MODIFICATION SHEET WAM4/33

Elimination of QTD 100 relay and BPQ 100 switch.

Modification Drg No. RDEO SK EL 2305.

ELIMINATION OF QTD 100
RELAY AND BEQ 100

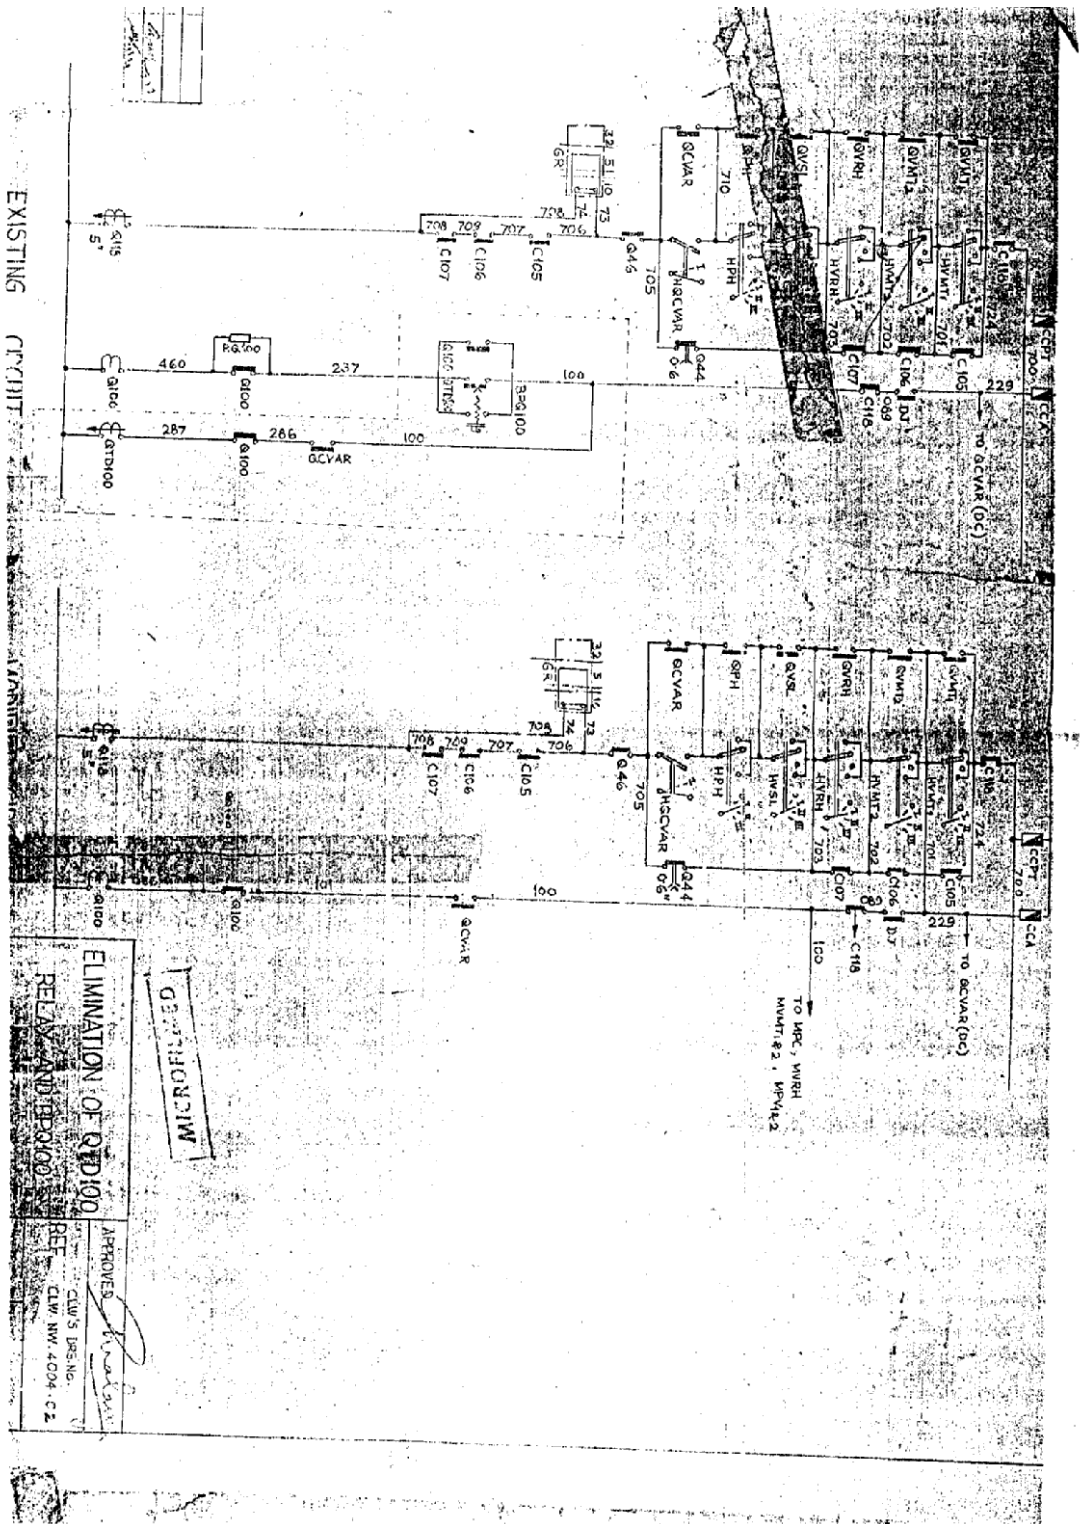
The first 84 locos provided with Siemens contactors C118 (without time delay) and associated time delay relay QTD 100 are to be eliminated when replaced by Alsthom contactor C118, which is provided with its own time delay contact.

The modification involves eliminating QTD 100 relay and BPQ 100 push button switch in I Q 100 circuitry.

The work is to be carried out on the first 84 locos which had been provided with Siemens Contactor C 118. This is to be undertaken by Railways during replacement of Siemens contactor by Alsthom contactor C 118 as per modification sheet No. WAM4/1F.
